ARCHITECTURAL REVIEW BOARD WORK SESSION AGENDA

Agenda Item: APPLICATION FOR NEW CONSTRUCTION, ARB #25-001, to consider an application for the construction of a new restaurant, Pollo Campero, with a drive-thru, located at 1131 Elden Street, Herndon, Virginia.

Prepared by: Bryce Perry, Deputy Director of Community Development

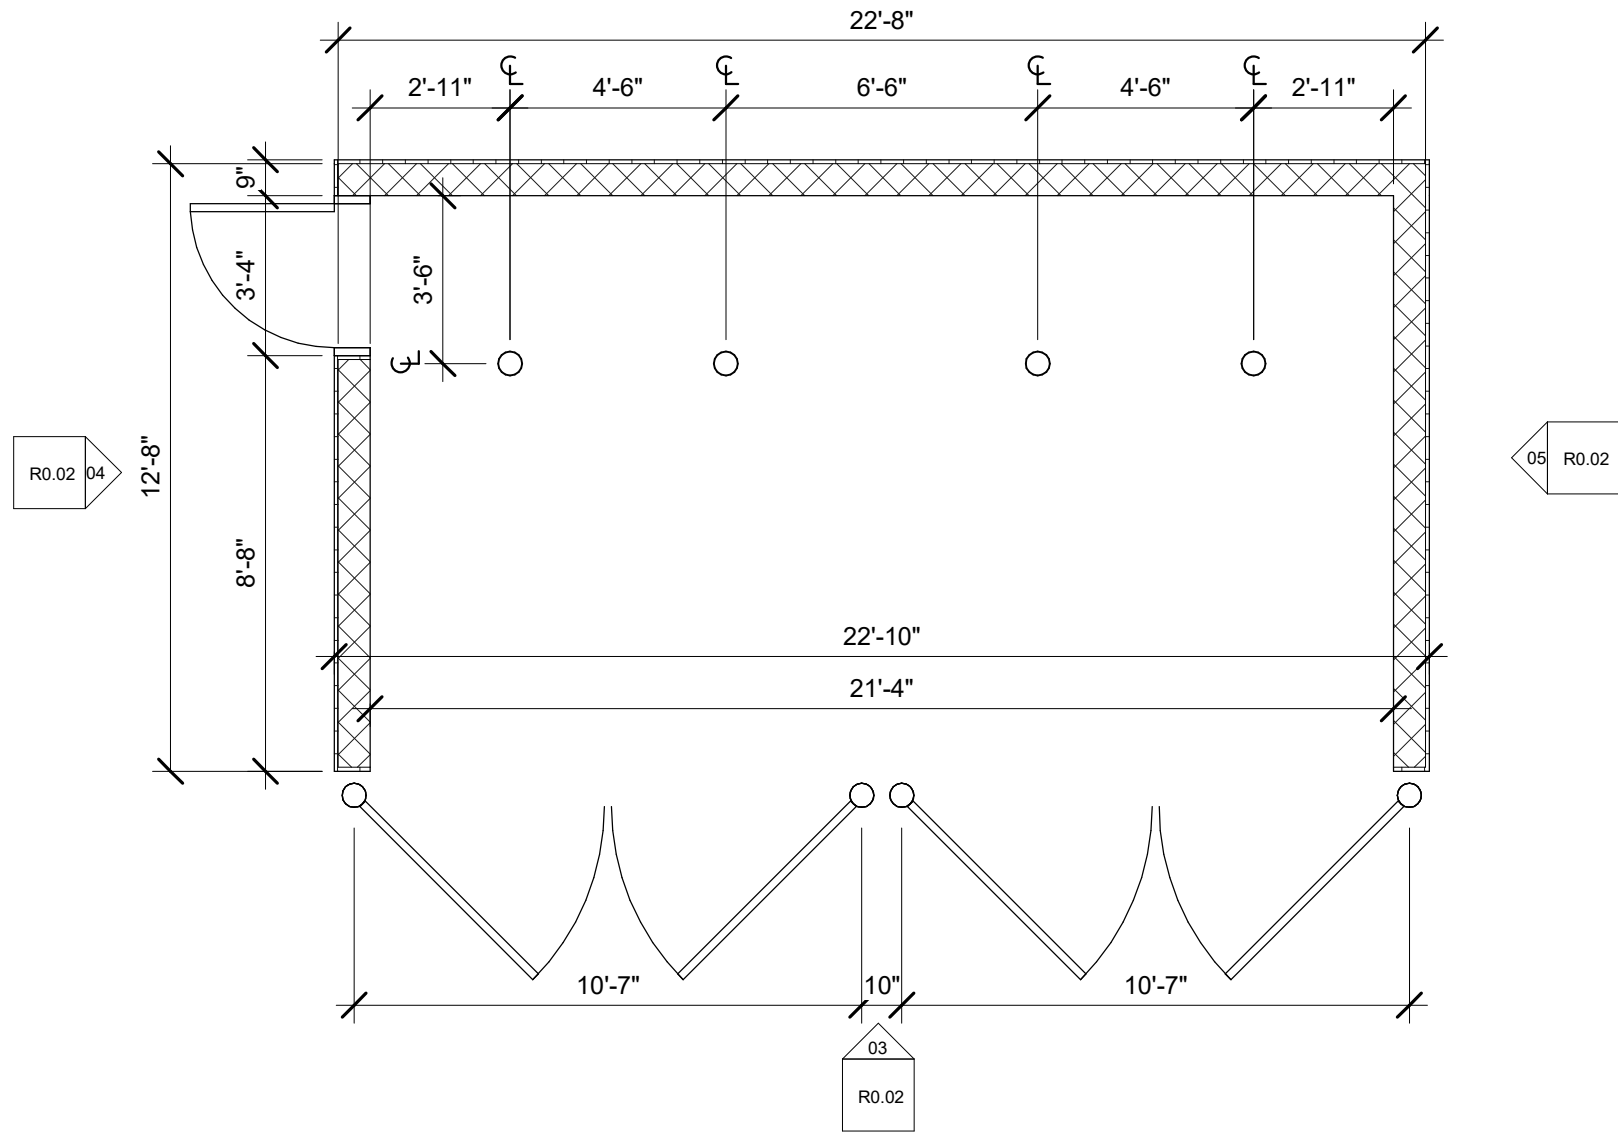
7. **Prior Revised Design.** In 2021, the applicant provided staff with a draft revised design, shown in the illustration below. This design was not reviewed by staff or provided to the ARB but is worth viewing to understand the possible ways in which items raised in this report and the previous memo may be addressed.

DRAWING TITLE:
REVIEW ELEVATIONS

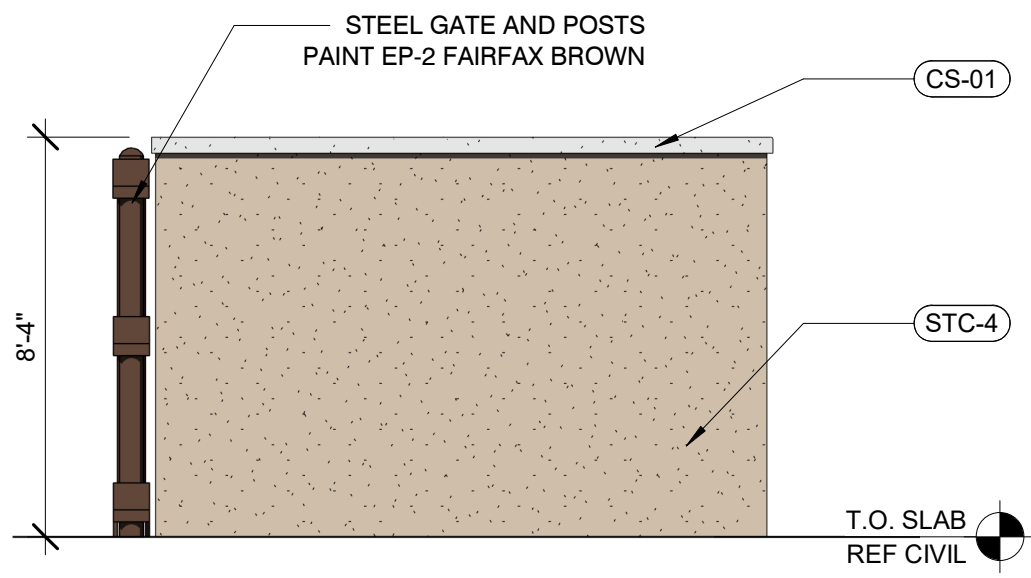
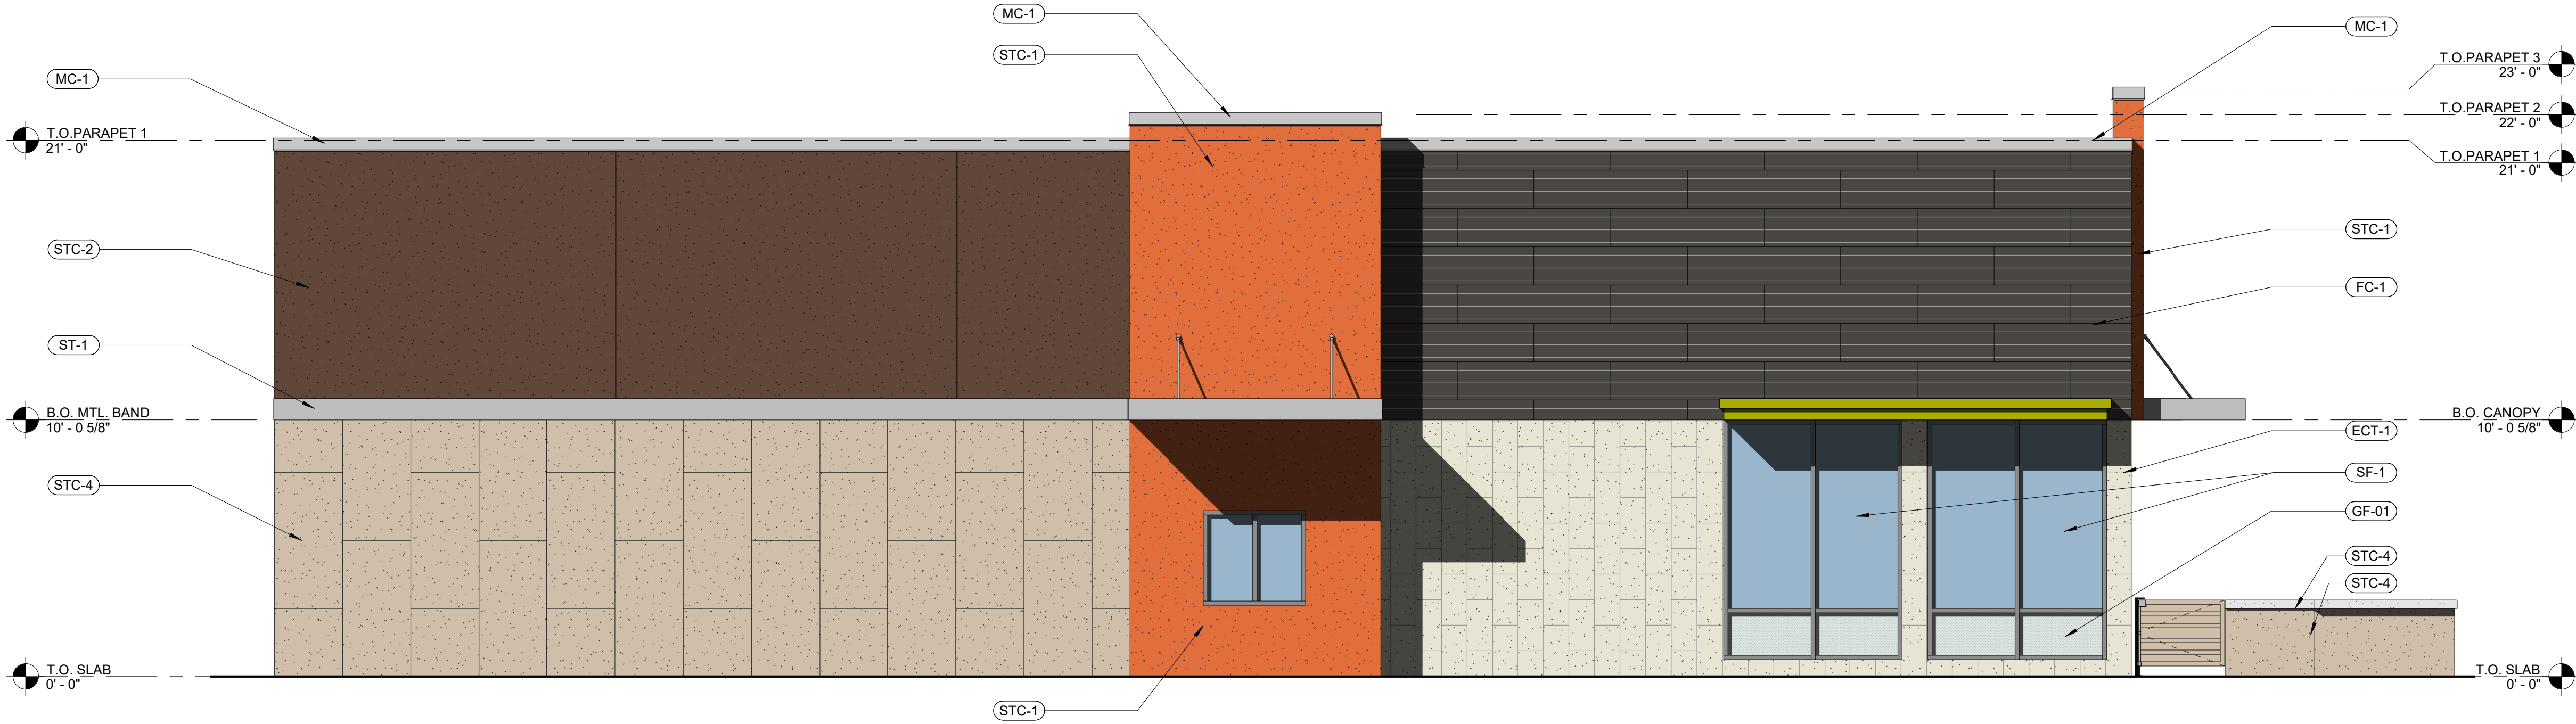
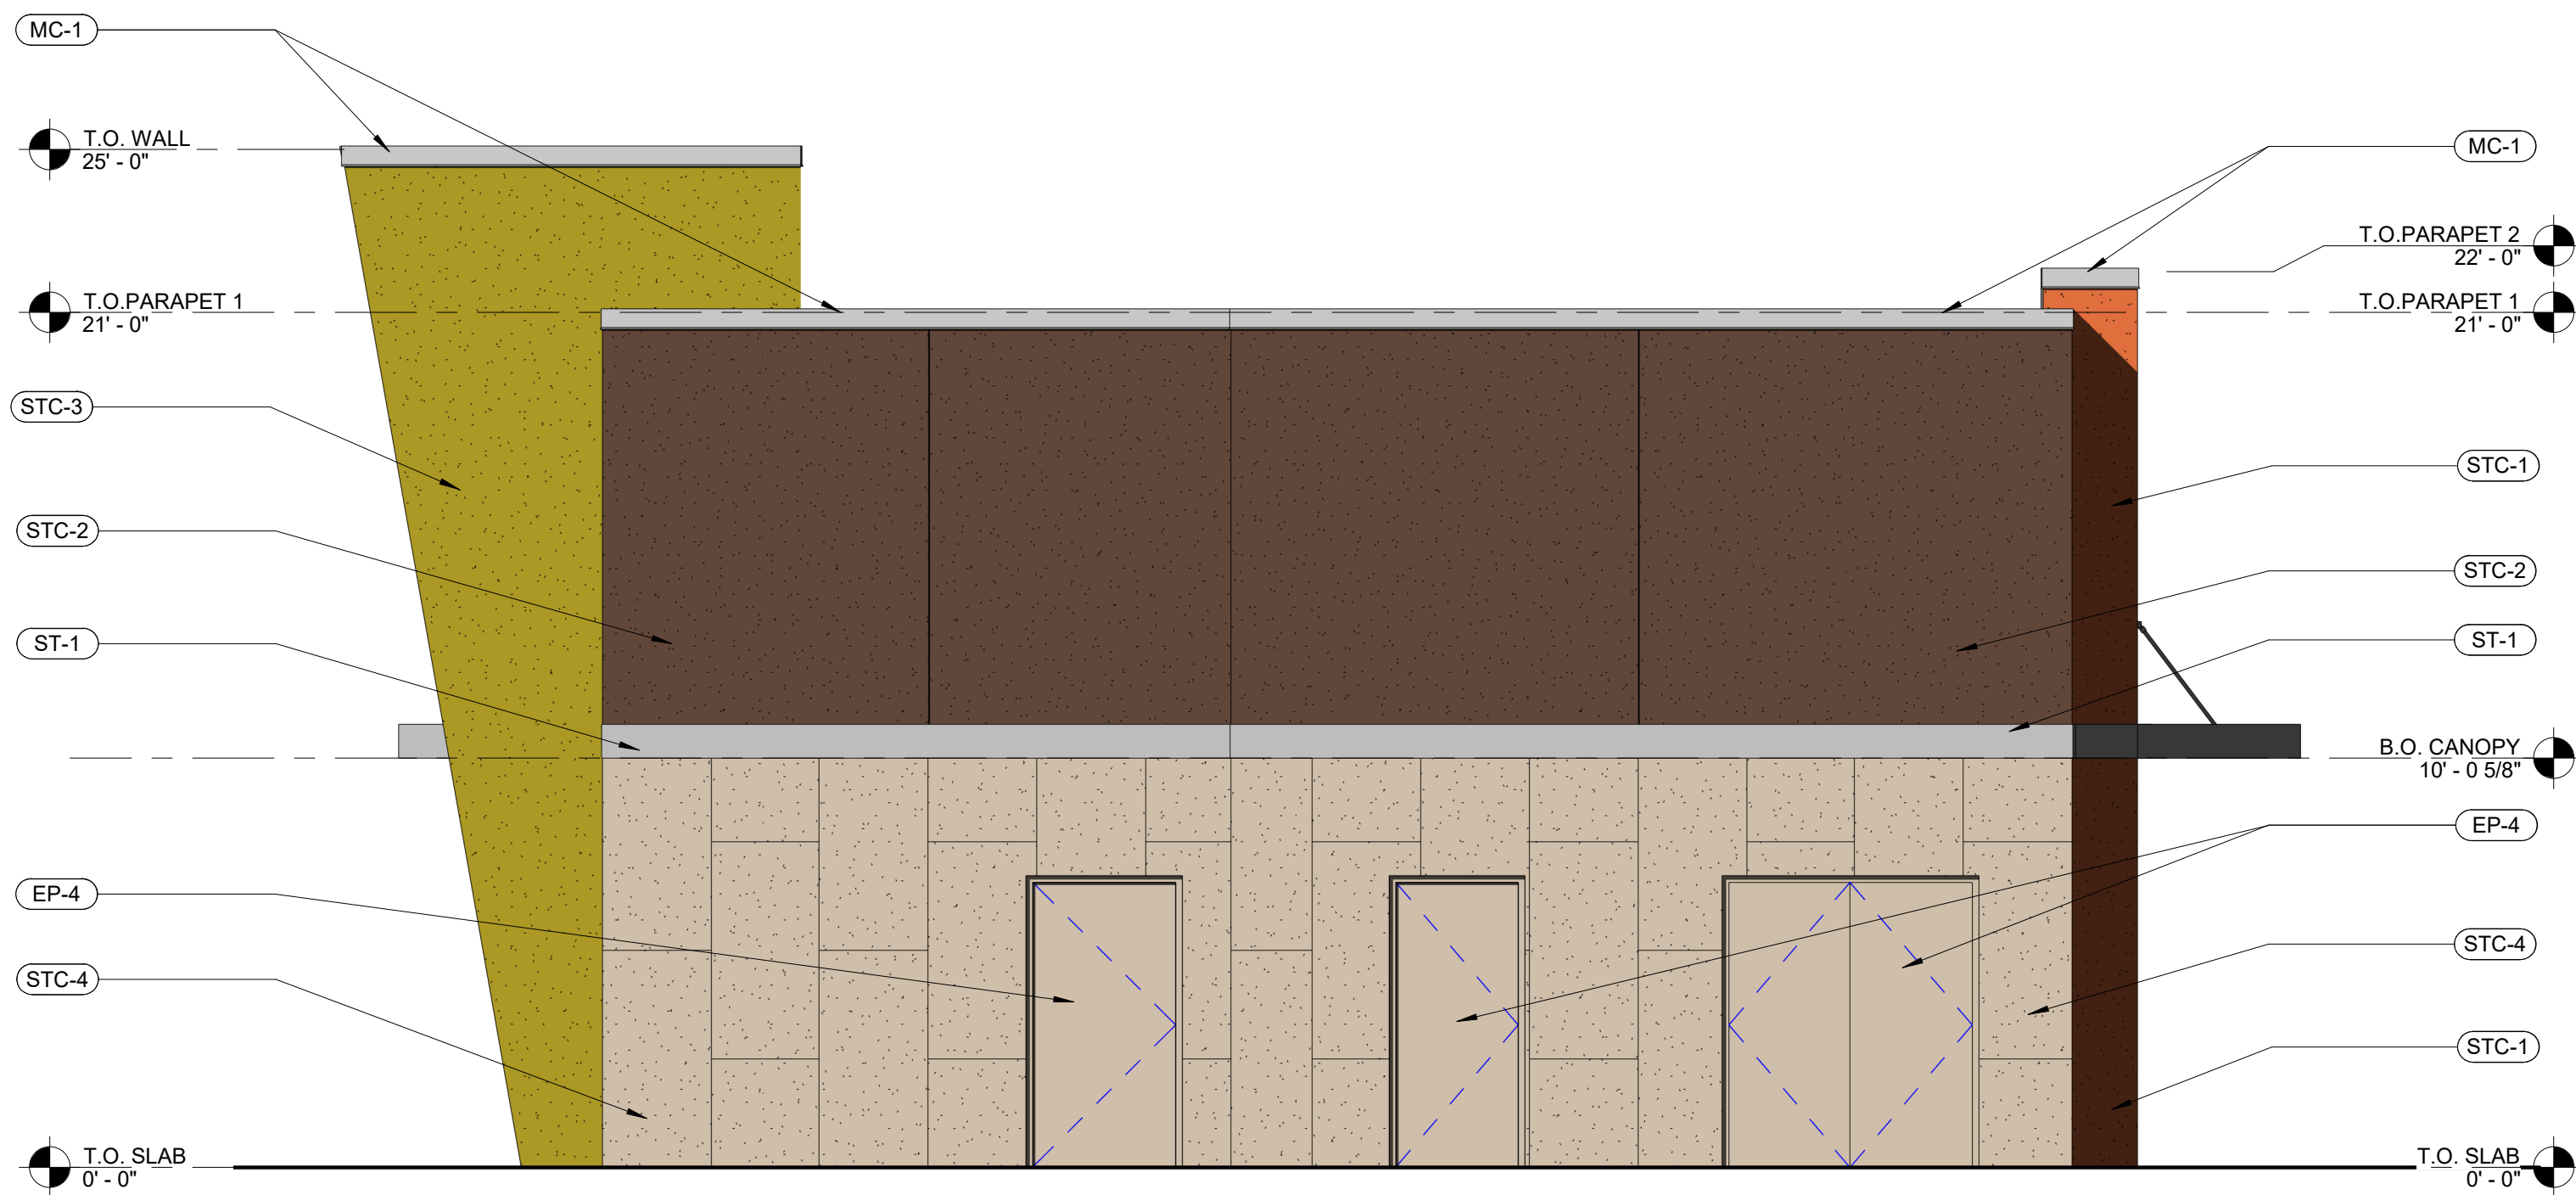
2. Exterior Materials and Colors. The last design standard for the Architectural Control District states that buildings should not be designed to serve primarily as an advertisement of commercial display or exhibit exterior characteristics likely to deteriorate rapidly or be of temporary or short-term architectural or aesthetic durability. This standard should be carefully considered by the board. The use of corporate colors in such a dominant manner on the building is at odds with this guidance, as is the use of the synthetic stucco system as the primary cladding material. Materials such as brick and other masonry units, clapboard siding, or vertical siding, which can be applied in both traditional and contemporary forms, would be better options to consider. Corporate colors should be limited to signage and outdoor seating umbrellas. See Comment #2 in the attached 2021 staff memo.

3. Diversity in Exterior Materials. The design includes a variety of exterior materials and colors. Staff has requested that materials samples be provided for the work session. The overabundance of exterior materials creates an overly complex design. Fewer materials should be used to simplify the design and a clear hierarchy of materials between field and accent materials would assist in organizing the design.

4. Facade Articulation. Creating notable breaks on the primary wall plane and roof plan can be appropriate methods for managing an over-simplified form and dealing with concerns of flatness and shallowness. This can be handled with large windows with maximized transparency and accent forms that carry down to the ground. It is unclear from the provided materials whether the windows will be fully transparent. A sample should be provided. The accent tower appendage on the front facade is a concern and should be removed or substantially redesigned. Its floating condition above the entrance seems unnecessary and awkward. Its very shallow return above the parapet reinforces its disposition as an intended sign panel. Prominent architectural forms strictly made to contain signage should not be included in the design.
